**Stormwater Management/BMP Facilities
Record Drawing/Construction Certification
Review Tracking Form**

County Plan No.: SP-105-97
 Project Name: CROMWELL RIDGE @ POWHATAN SECONDARY
 Stormwater Management Facility: DRY POND

Project: CROMWELL RIDGE AT POWHATAN SECONDARY
BMP Facility: DRY POND
Plan No. SP-105-97
BMP ID Code: PC131

**BMP Modification Plan
for
Earth Berm Cutoff Wall**

CUT VIEW OF BERM, WALL AND SPILLWAY

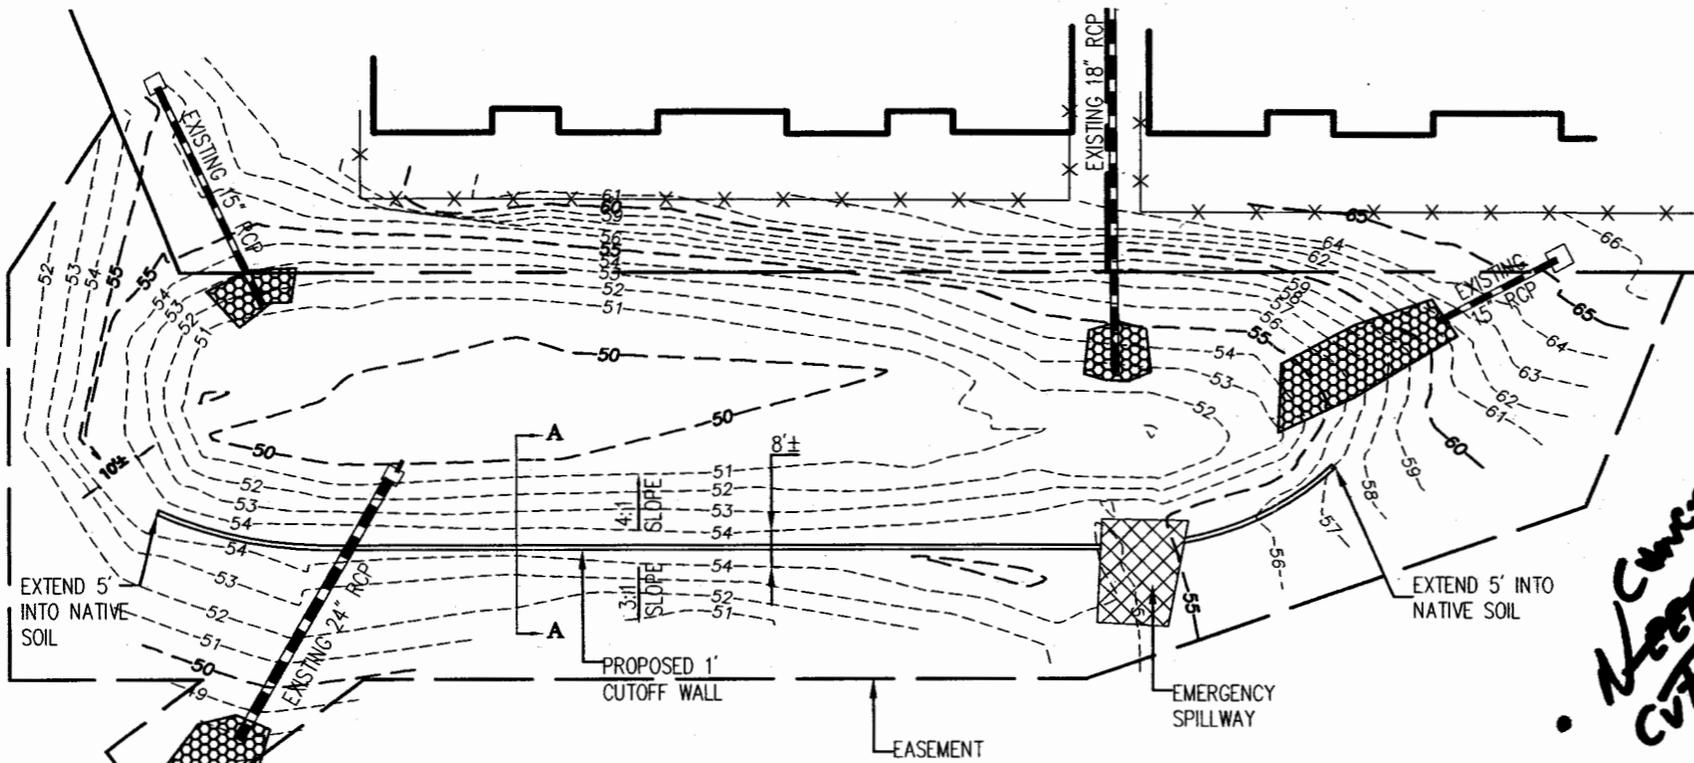
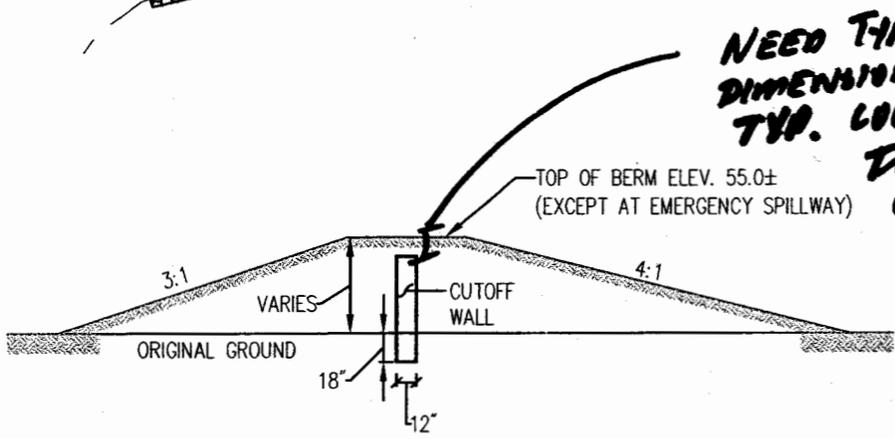
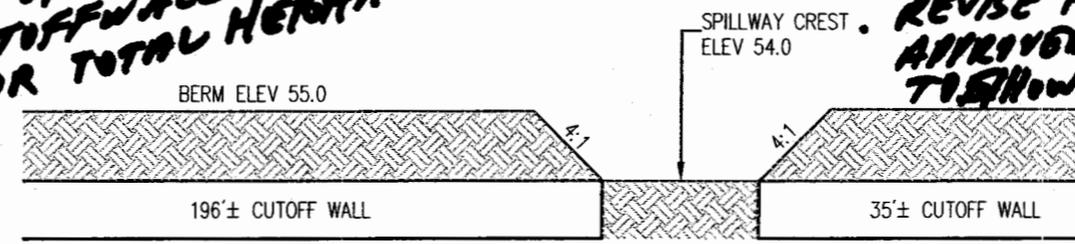
C.O.W =
CUT OFF WALL.

*Concrete
Need space for
CUTOFF WALL Material
i.e. clay Bentonite,
etc.*

*ETS CONTRU
CONST COST FOR
CUTOFF WALL
NEEDED.*

*REVISE PREV
APPROVED AS-BUILT
TO SHOW FINAL
C.O.W.*

*NEED TYPICAL
DIMENSION FOR
TYP. LOCATION
TOP OF
CUTOFF WALL
OR TOTAL HEIGHT.*
